Re: Letter of Intent - Resubmitted

20120410 - Pacific Cycle - Office Expansion

- 1 GRADING AND EROSION CONTROL PLAN

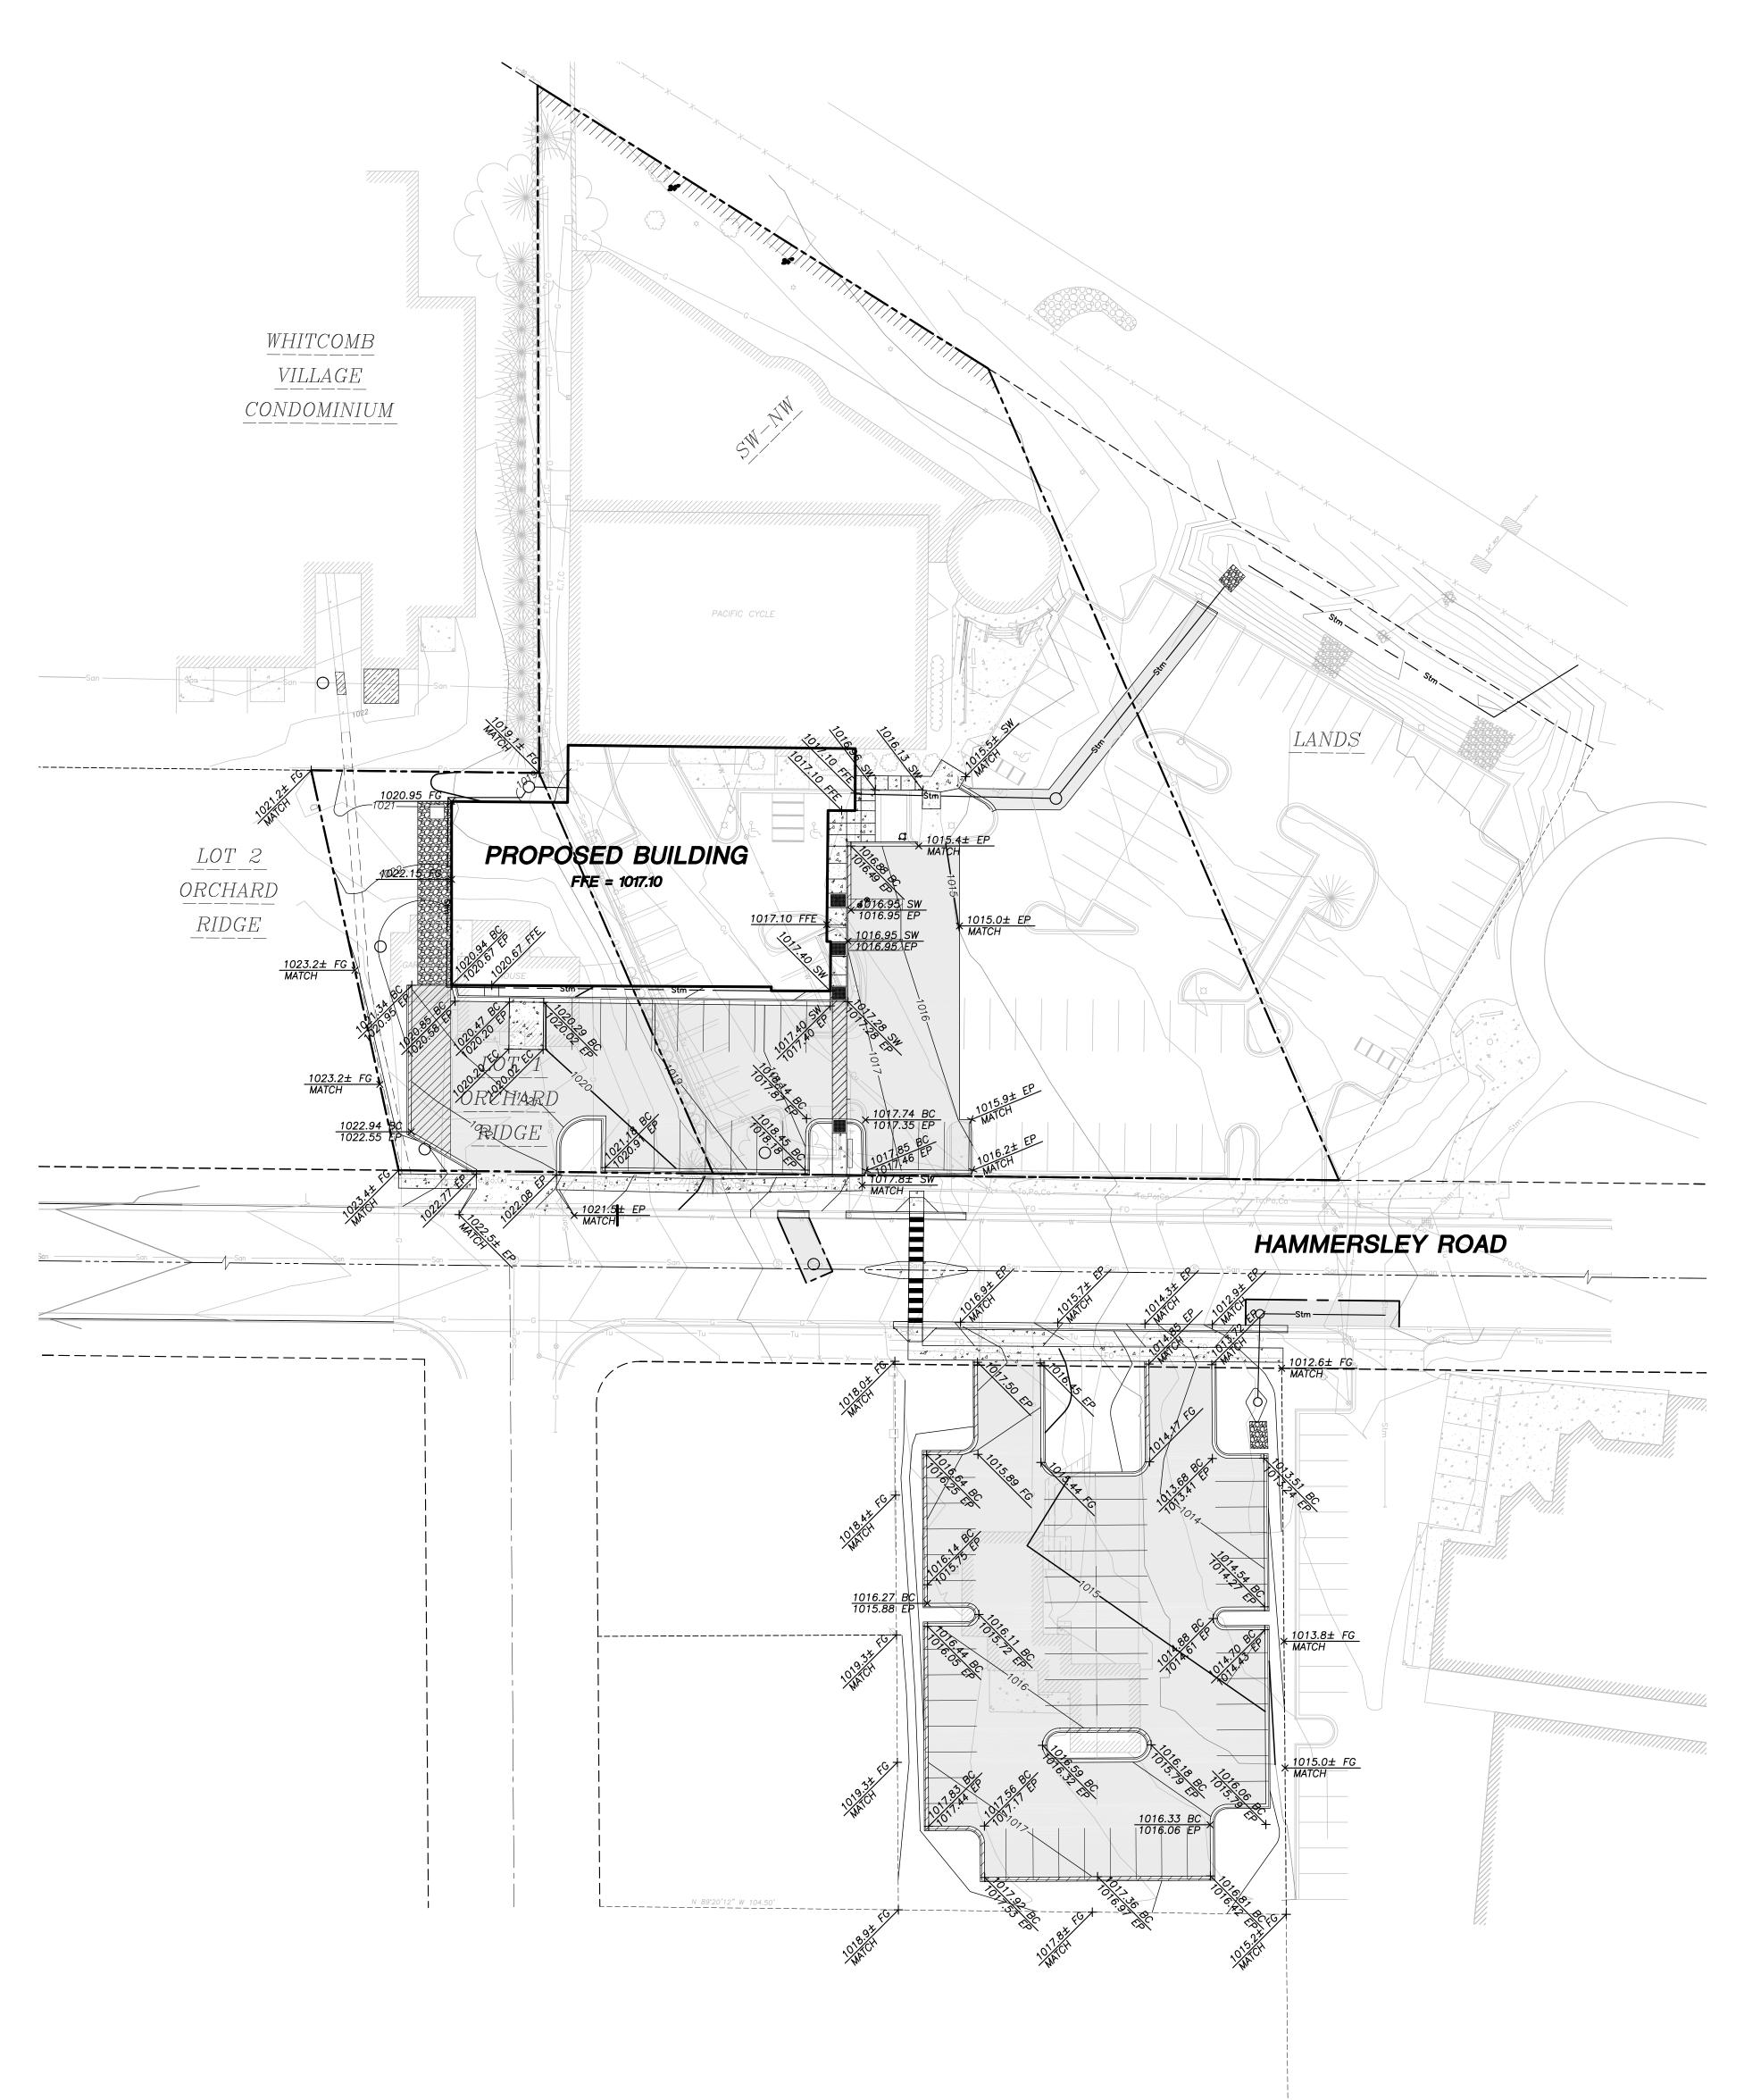
Also attached are revised Civil drawings with proposed utility locations and stormwater management. The revisions reflect the modifications associated with the addition shifting east.

L100

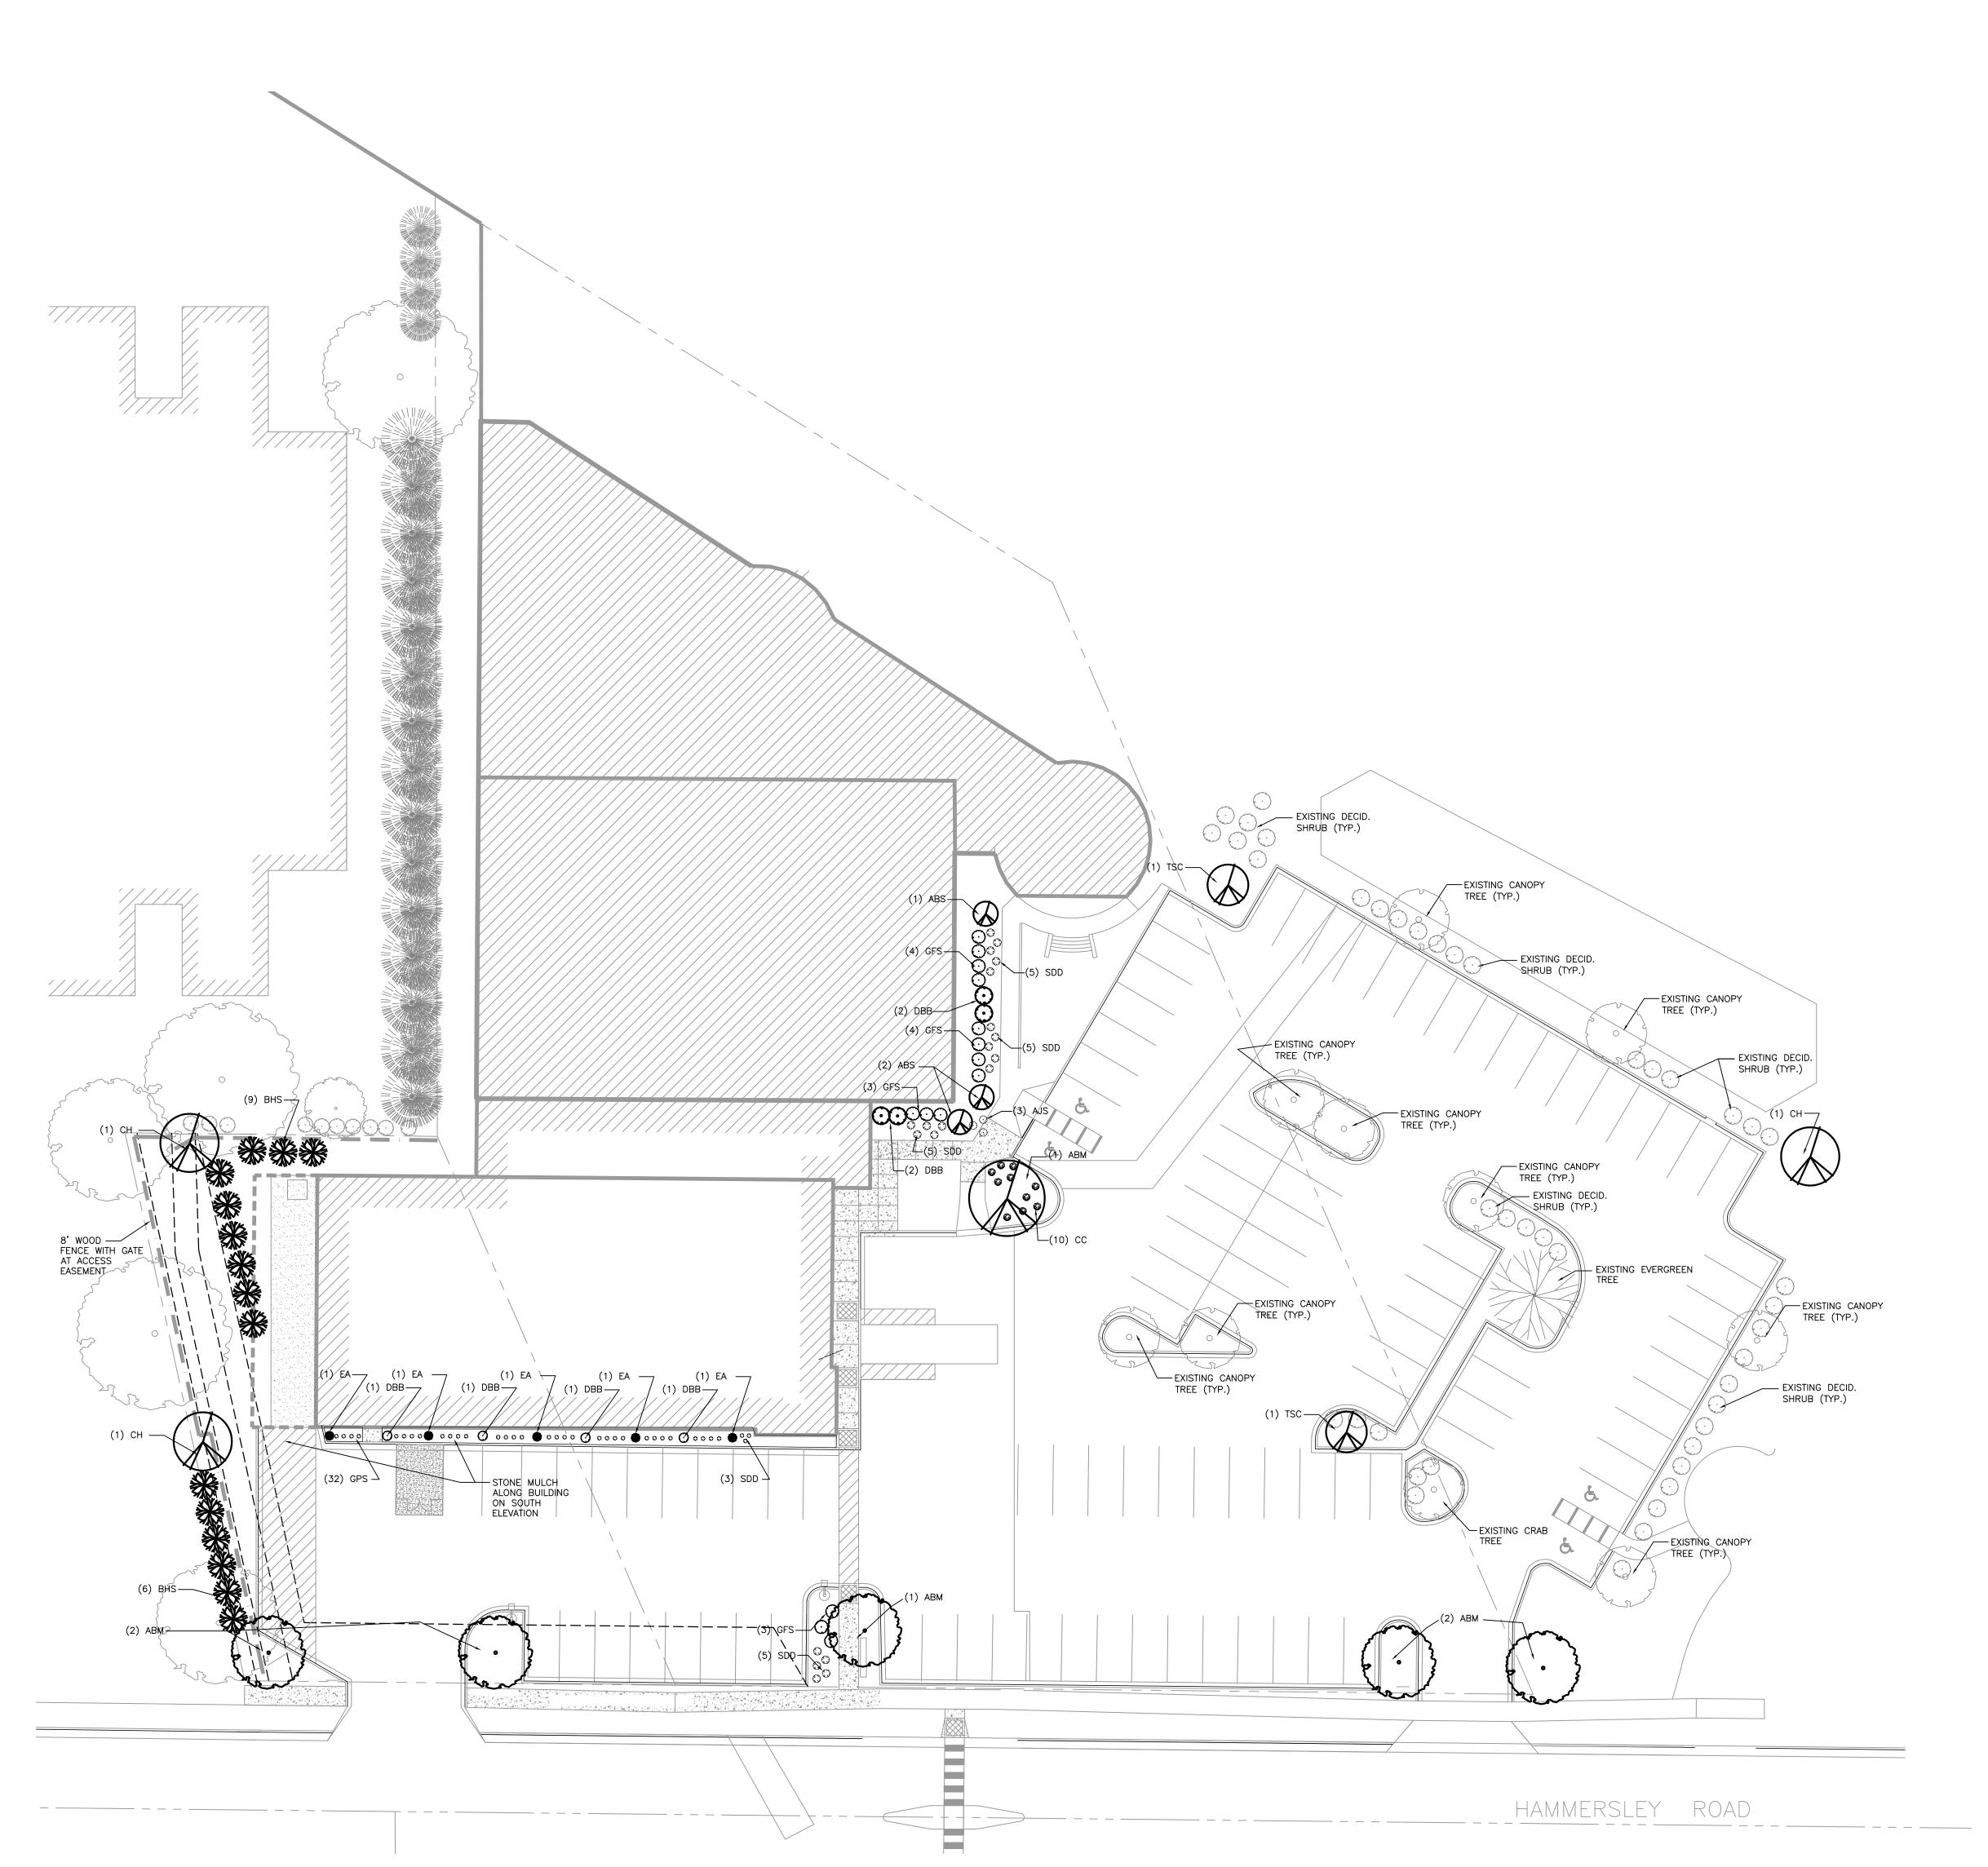
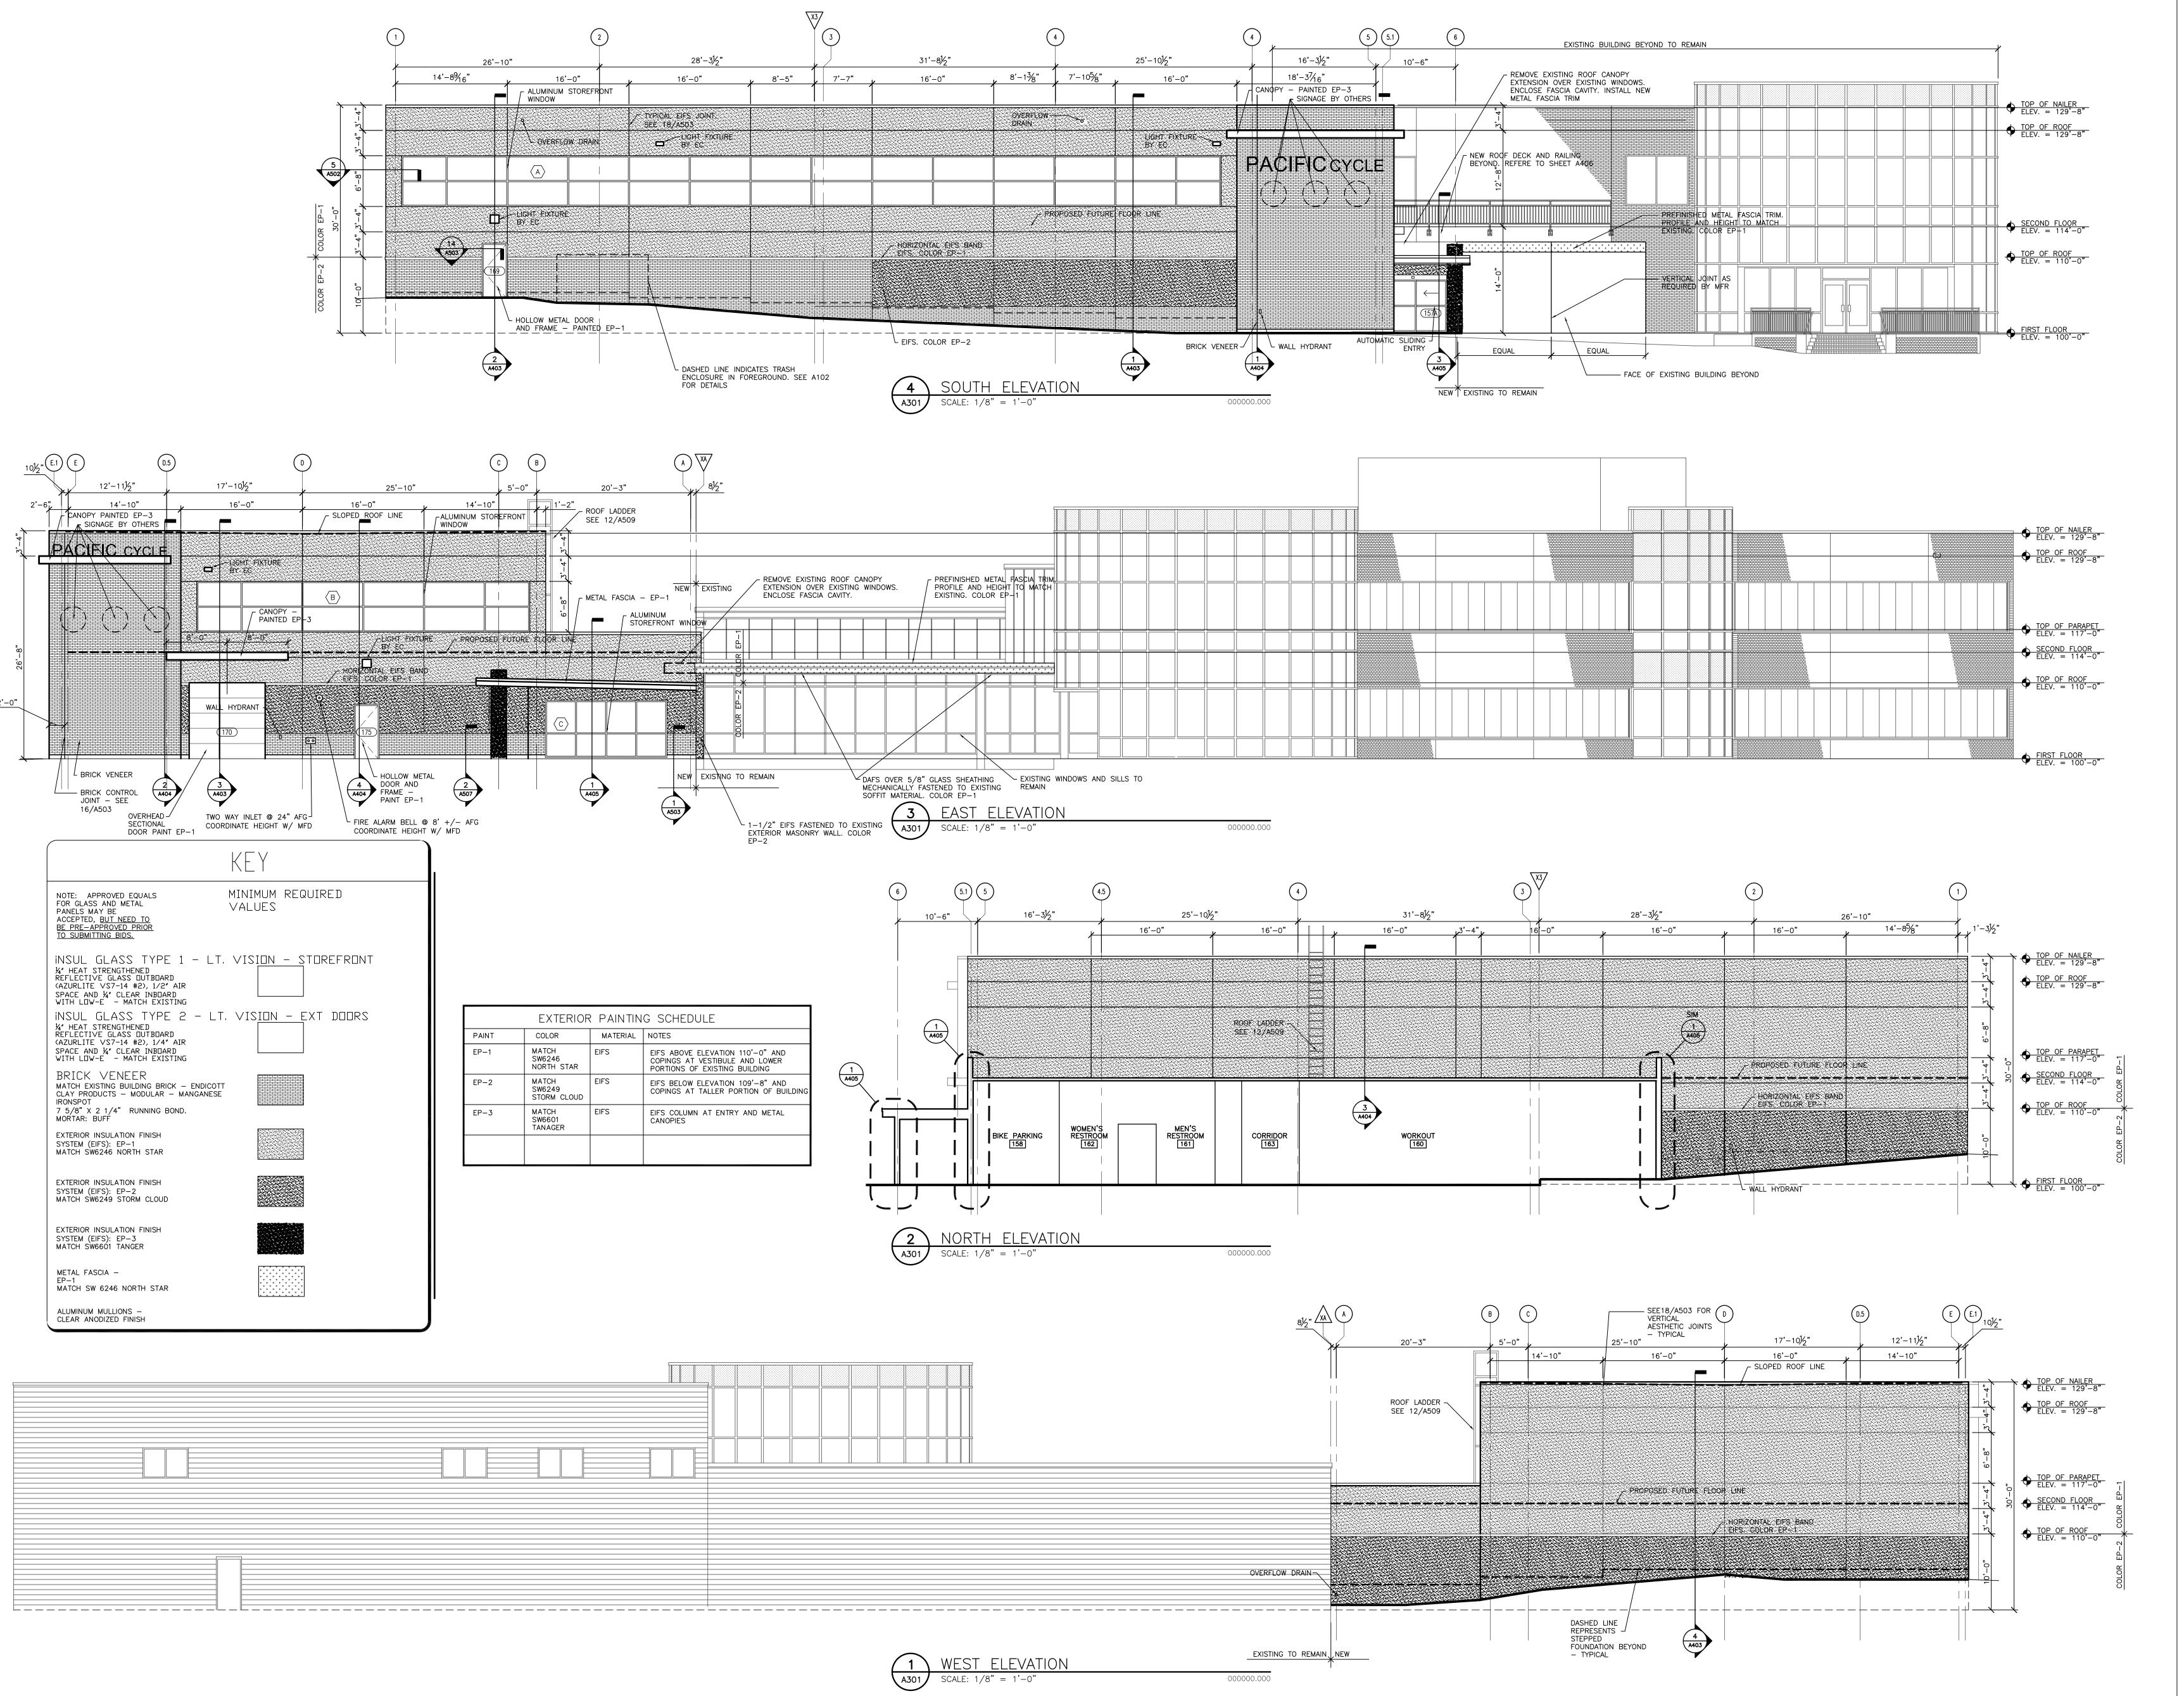
In response to staff, neighbor's and Commission concerns on the parking issues, we have updated the drawings to provide a decorative wood fence separating the proposed lot at 4817 Hammersley from the adjacent residential neighbors. Landscaping will be provided outside of the fence to soften the edge. The height of the fence will be set at the highest allowable by Zoning. Additionally, a decorative wood fence will be provided on the west and north edges of the 4908 property to screen the parking lot and building from the adjacent residential lots. This too will have landscaping provided to aid in screening and softening the edge.

We have worked to locate the curbs and gutters to allow for retention of as many existing trees as possible on the 4817 Hammersley site. Stormwater management designs have been revised such that 2 large existing trees located in the northwest corner of the site should be able to be preserved. These trees have been identified on the revised site plan along with approximate locations of existing trees to remain on the adjacent neighbor's lots.
